SUBJECT: SOURCE RANGE MONITOR COUNT RATE CURVE (TAC NO. 74572)

RE: LIMERICK GENERATING STATION, UNIT 1

Amendment No. 34
License No. NPF-39

SAFETY EVALUATION BY THE OFFICE OF NUCLEAR REACTOR REGULATION

FIGURE 3.3.6-1

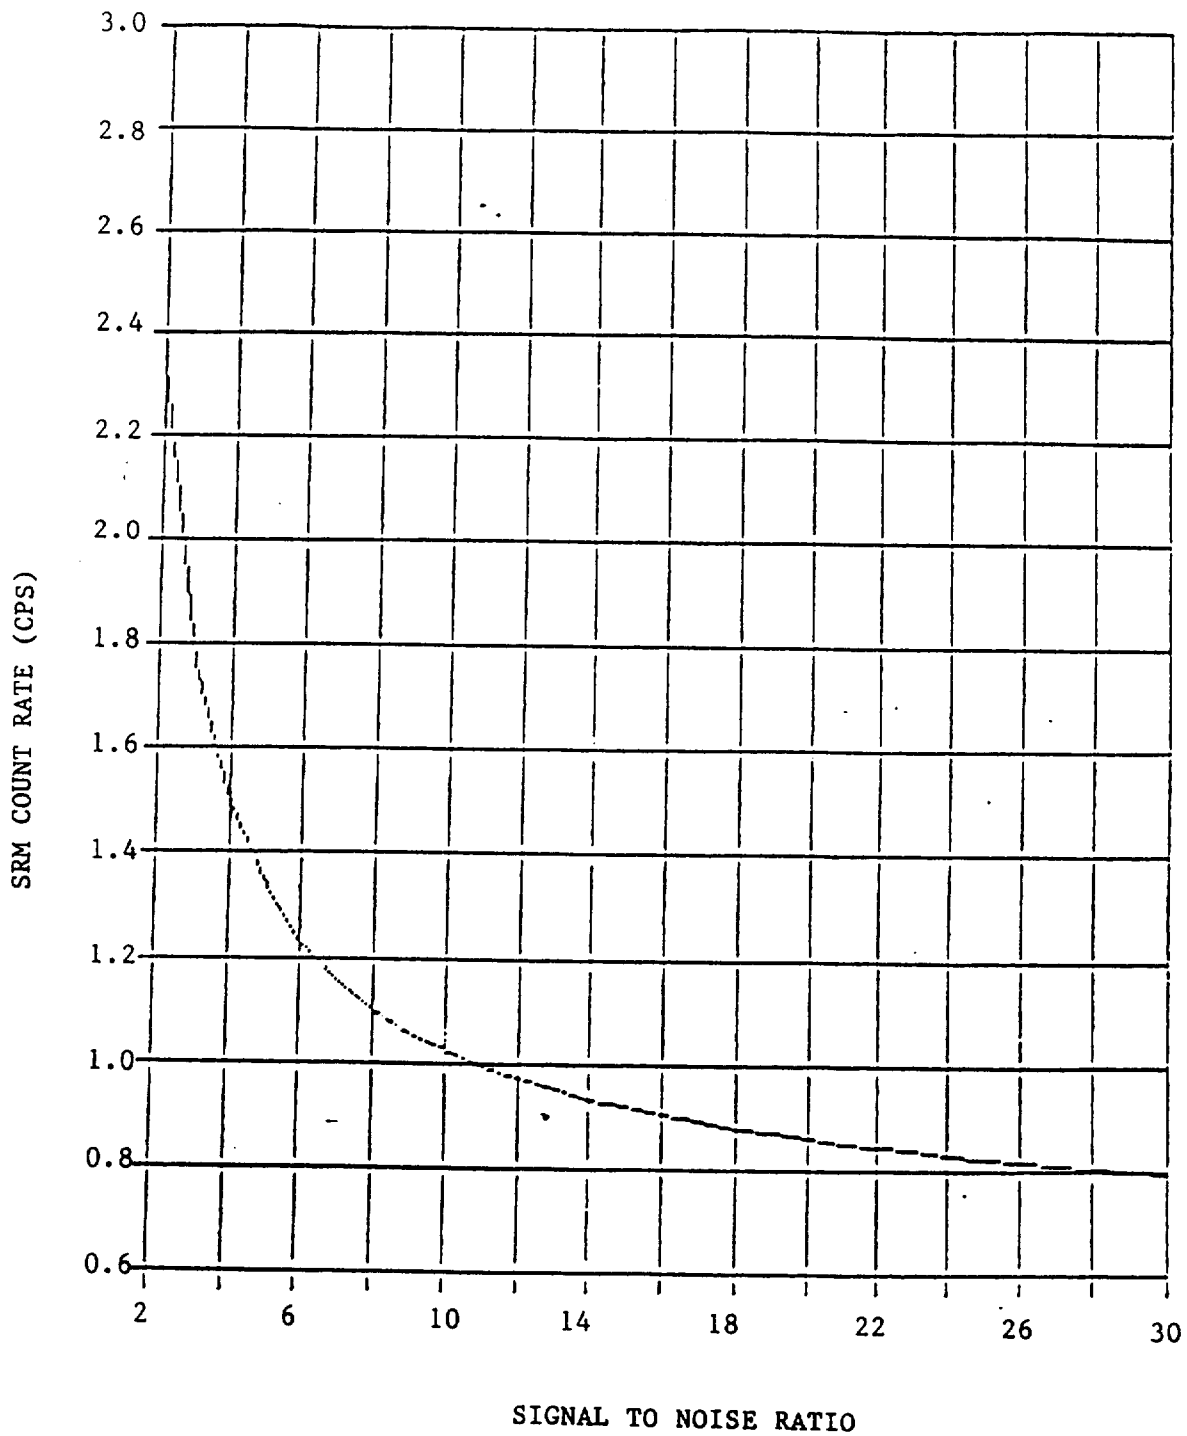
- 1) Insert Figure 3.3.6-1 on new page 3/4 3-60b, "SRM Count Rate versus Signal-to-Noise Ratio."
- 2) Revise Table 3.3.6-2 on Page 3/4 3-60a, TS section 4.3.7.6 on Page 3/4 3-88, and TS Section 4.9.2 on Page 3/4 9-4, to permit reduction of the minimum required SRM count rate below 3 cps "provided the Source Range Monitor has an observed count rate and signal-to-noise ratio on or above the curve shown on Figure 3.3.6-1."
- 3) Revise the index on Page viii to include Figure 3.3.6-1.

Since 0.8 cps, the lowest count rate shown on Figure 3.3.6-1, corresponds to approximately 8×10^{-9} of rated power, we have concluded that reducing the downscale setpoint in accordance with Figure 3.3.6-1 will not invalidate the assumptions used in the transient analyses. Stipulating a signal-to-noise ratio in accordance with Figure 3.3.6-1 assures that the SRMs are indeed responding to neutrons and the neutron flux level with the reactor critical will be well above 10^{-8} of rated power due to subcritical multiplication.

The curve presented in Figure 3.3.6-1 was derived by General Electric Company specifically for LGS Unit 1. The technical basis for this curve is presented in General Electric Company Report EDE-47-1188, "SRM Count Rate vs S/N Ratio for Philadelphia Electric Company, Limerick Unit 1," dated December 2, 1988. The curve ensures the same level of confidence at lower cps setpoints as is provided at the nominal 3 cps setpoint. The 3 cps setpoint is based on an assumed signal-to-noise ratio of two, which yields a statistical neutron monitoring confidence of 95% that the indicated signal is correct. At lower cps setpoints, a higher signal-to-noise ratio is required to maintain the same level of counting certainty. The inverse relation between cps and signal-to-noise ratio depicted in Figure 3.3.6-1 ensures the 95% confidence level.

**May be reduced provided the Source Range Monitor has an observed count rate and signal-to-noise ratio on or above the curve shown in Figure 3.3.6-1.
